RE: Project: PR-2022-007565; SP2025-00075- SITE PLAN DFT Comment responses

To whom it may concern,
I am in receipt of comments provided on 10/22/2025 and have provided the following revisions, and responses to those comments:

AS001

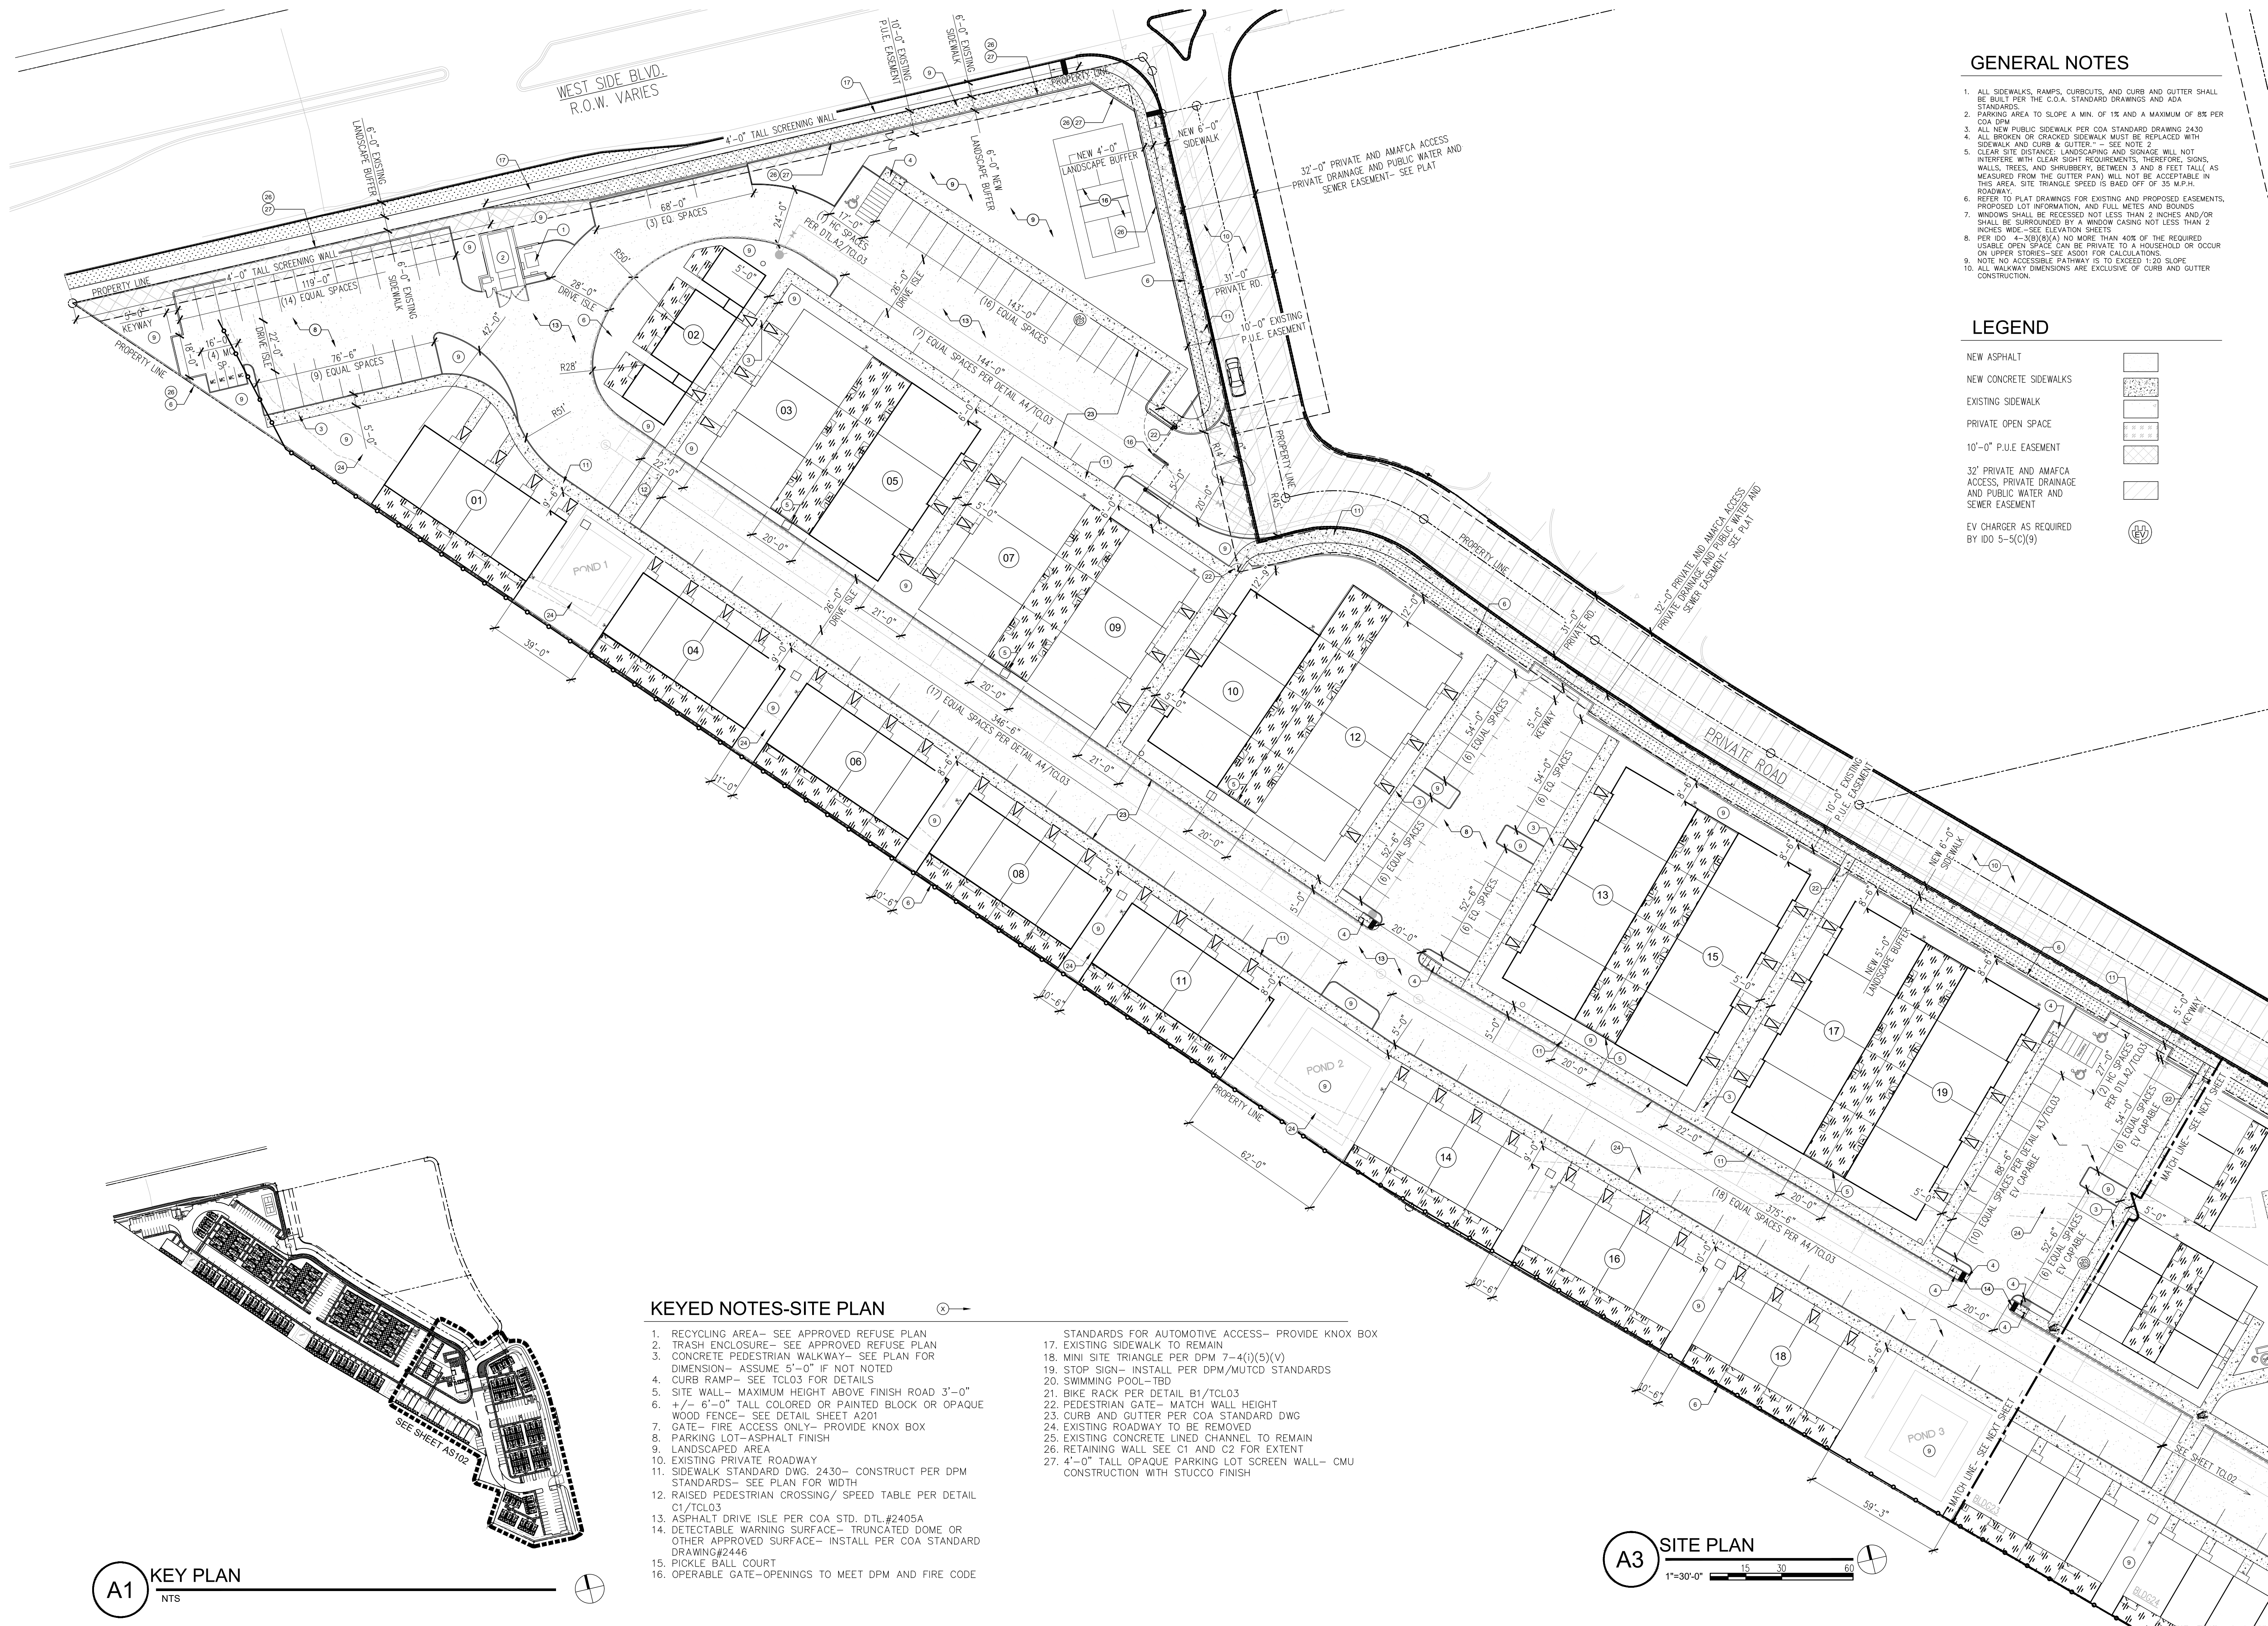
4. Project and application numbers must be added to the Site Plan.

Response: Project and application numbers have been added to the site plan/ signature page.

LP-02

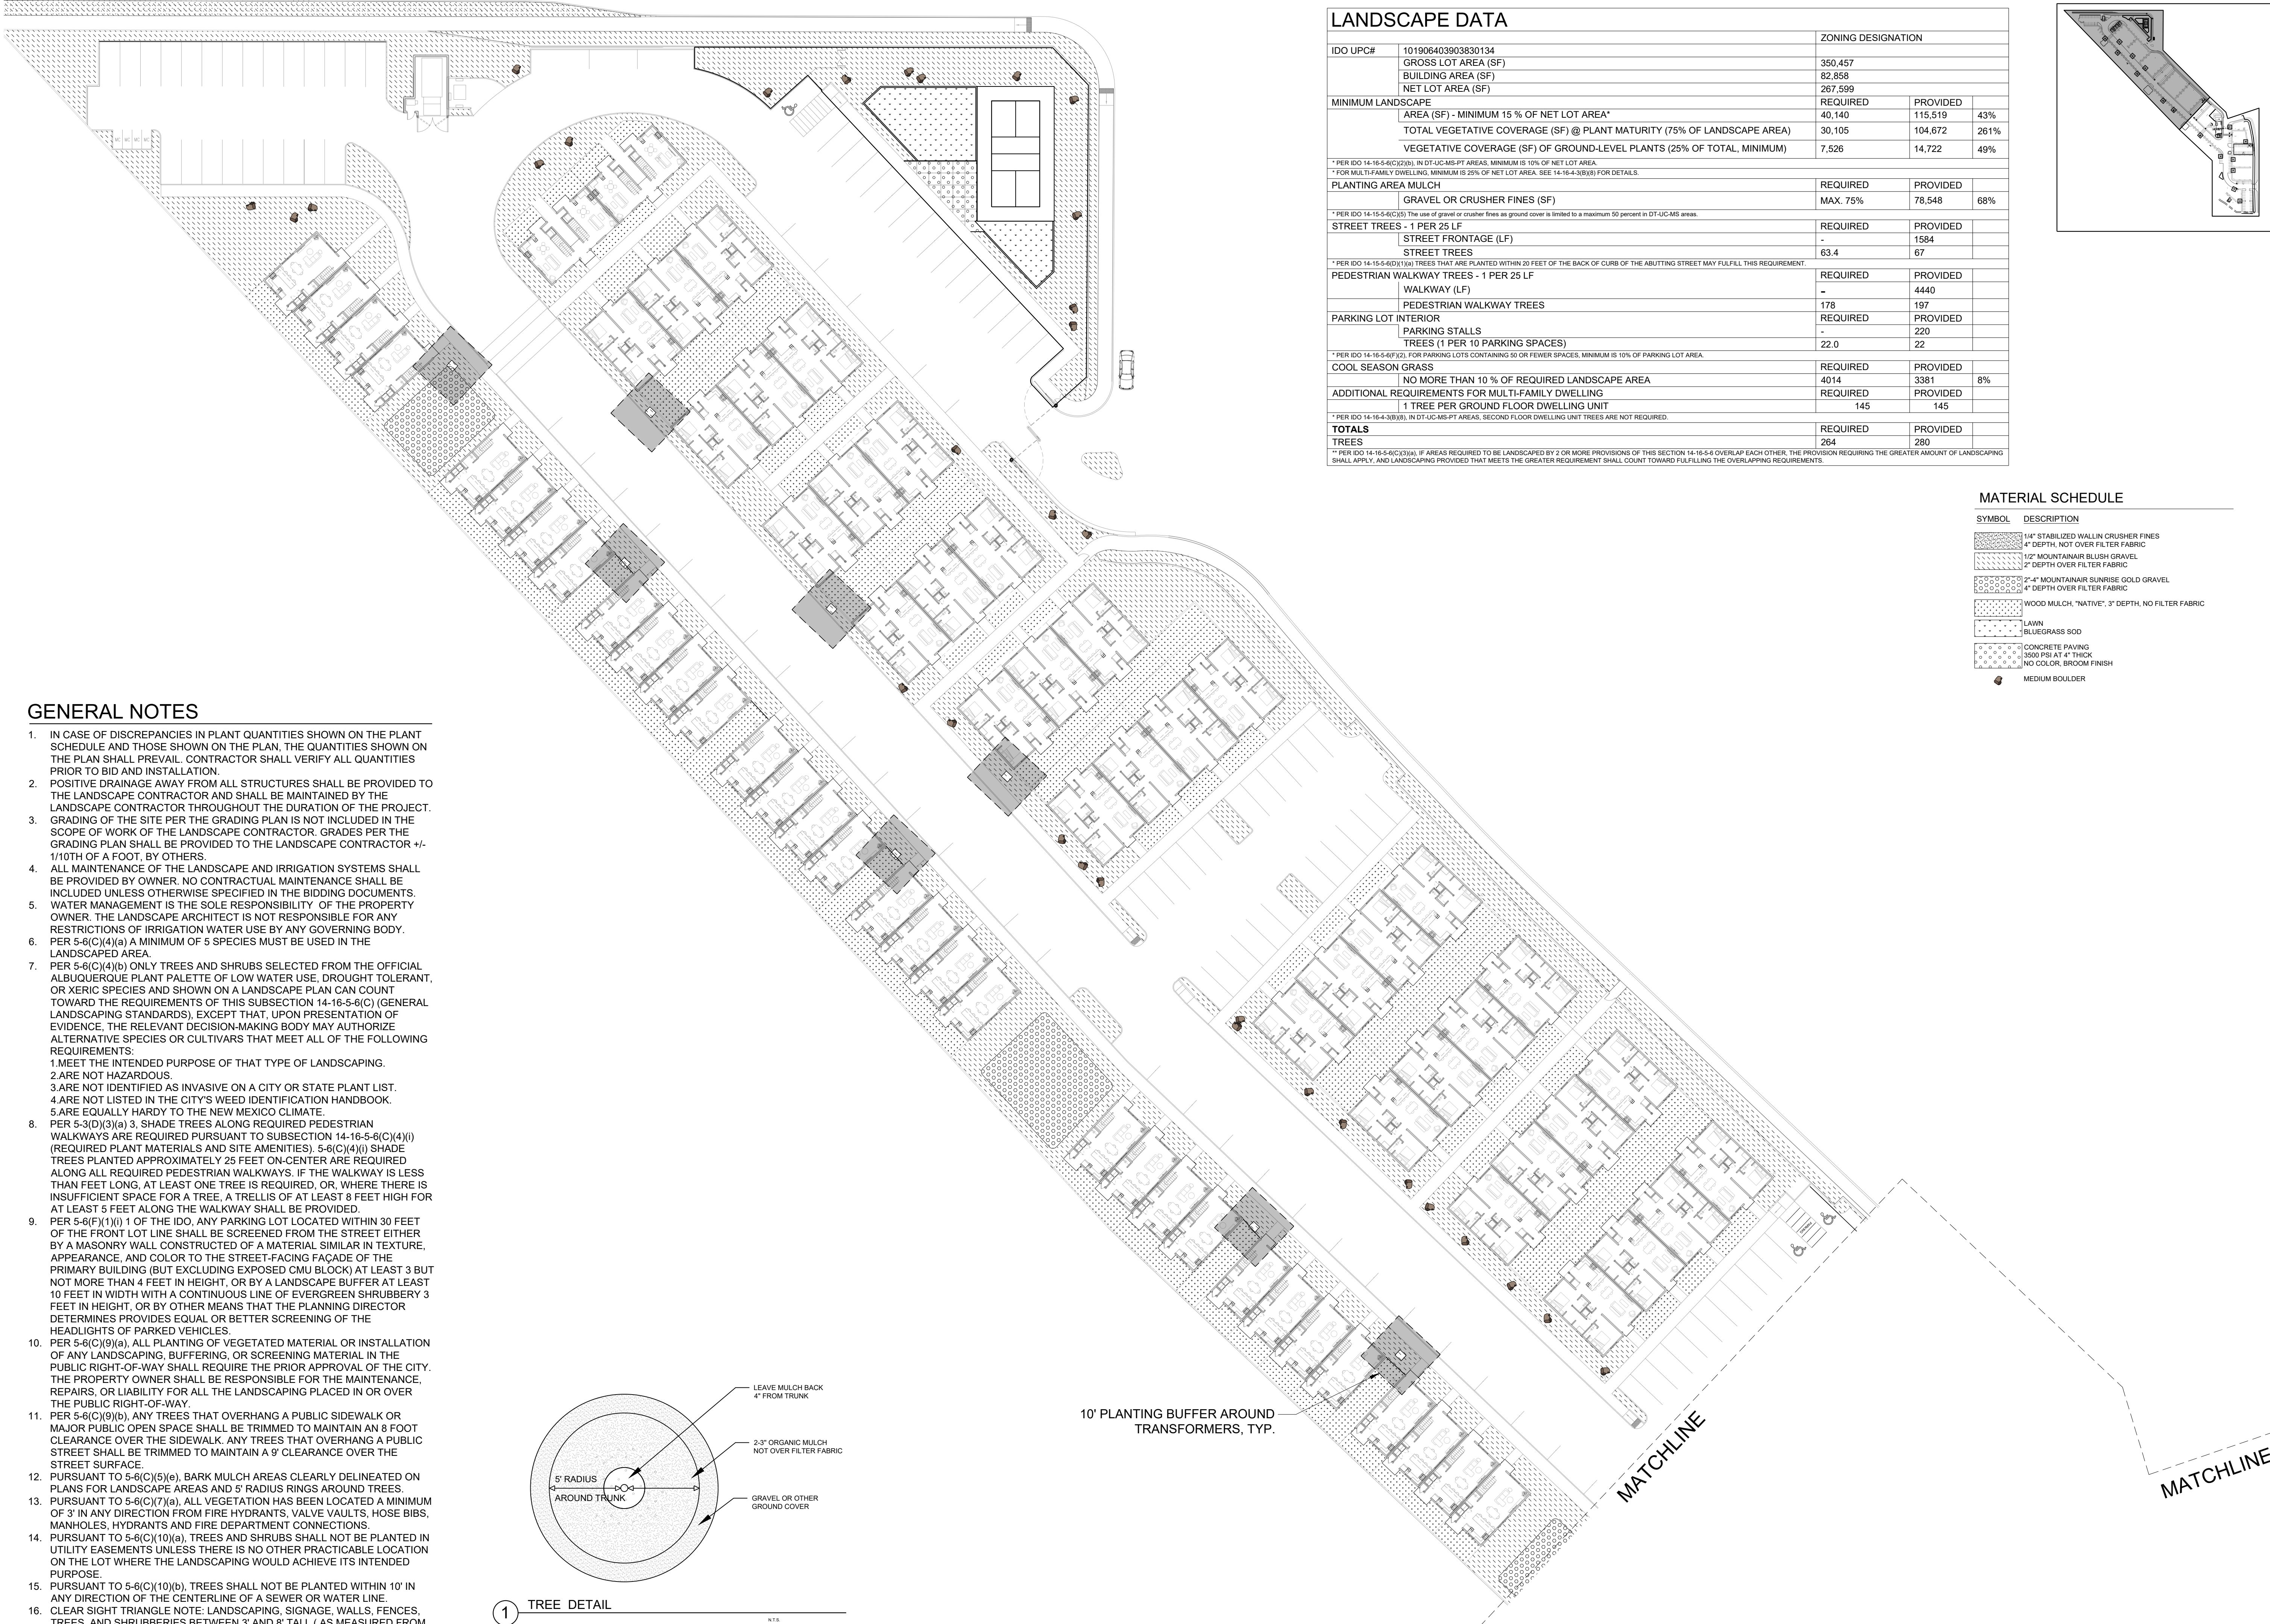
2. One (1) tree is required per 10 parking spaces. Calculations must be added to the landscape plan data.

Response: This has been added to drawings

ENGINEER'S SEAL	JAY REMBE SUBDIVISION	AS
		ALBUQUERQUE, NM	06-11-25
	MASTER UTILITY PLAN	2024054_MUE	
	 5571 MIDWAY PARK PLACE NE ALBUQUERQUE, NEW MEXICO 87109 (505)858-3100	SHEET #	MU-3
	RONALD R. BOHANNAN P.E. #7868		JOB # 2024054

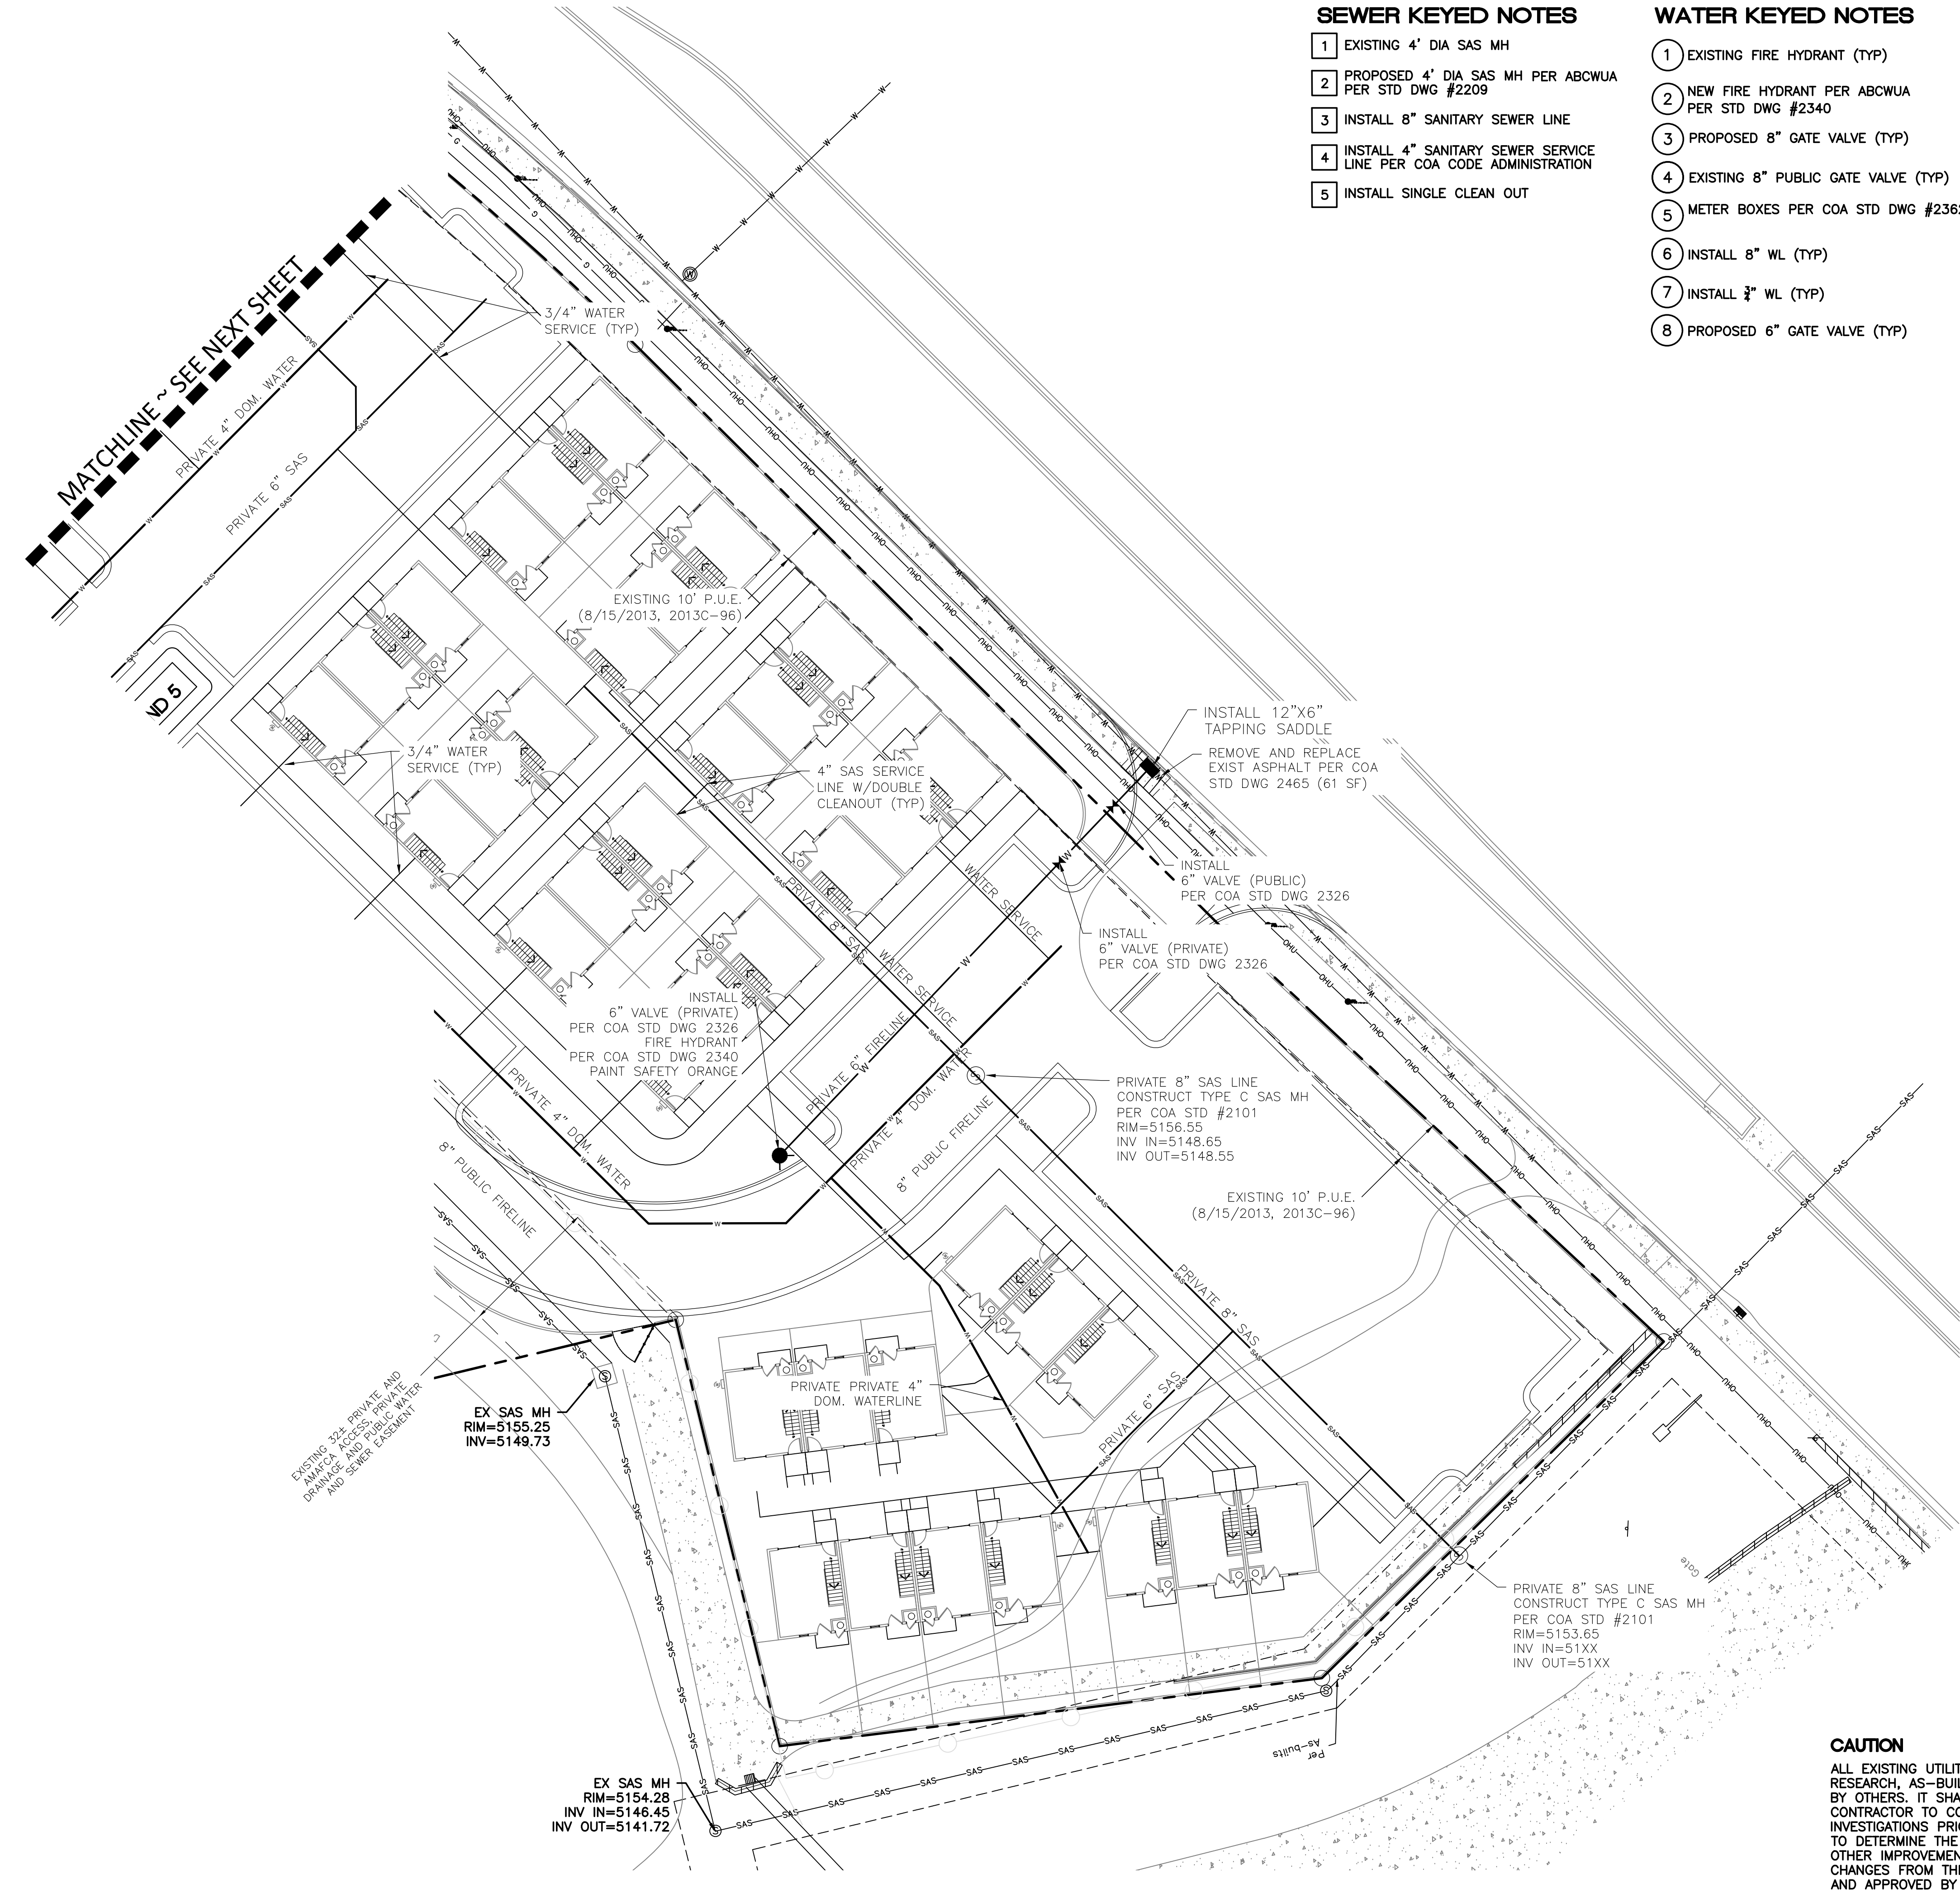
3. Need to show all utility easements as "public" or "private" and dimension each easement.

Response: All existing easements have been labeled on the master utility plan. No additional easements are being requested, public or private.
